PRODUCT/PROCESS CHANGE NOTICE (PCN)

PCN #: **L-0405-04** DATE: 5/19/2004
Product Affected: VFQFP (NL/NLG28/40/52/56/68)
packages shipped in Tape and Reel

ATTACHMENT - PCN #: L-0405-04

FROM:

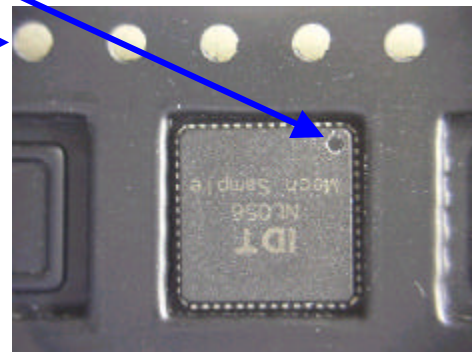
PCN Type: To comply to current EIA Standards (EIA-481-B) requirement.
Data Sheet Change: No
Detail of Change: This change will be implemented on all VFQFP packages.

Electrical Pin 1

Round
Sprocket
Holes

TO:

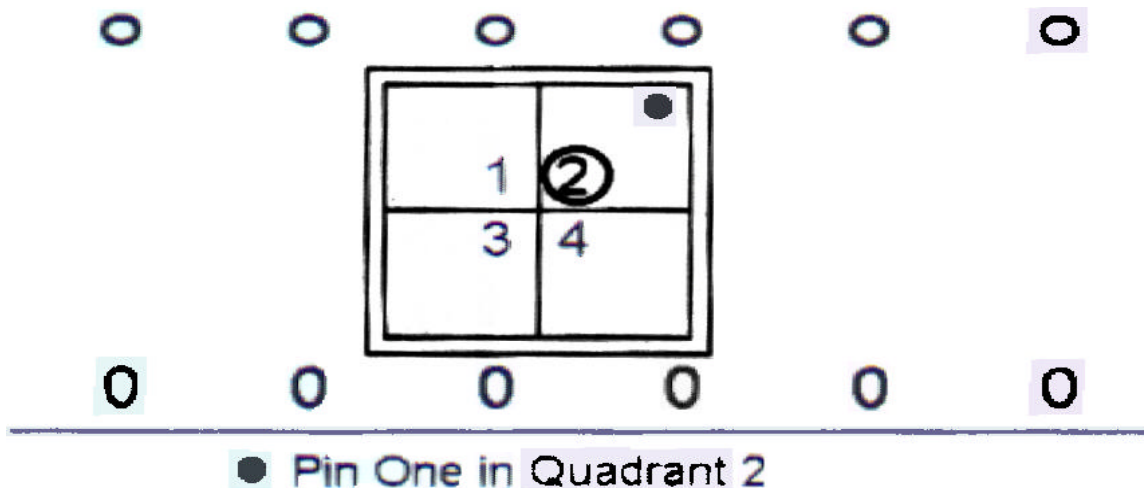
Additional label will be placed on the intermediate box (pizza box), reel and ESD/moisture barrier bag to alert customer of this change.
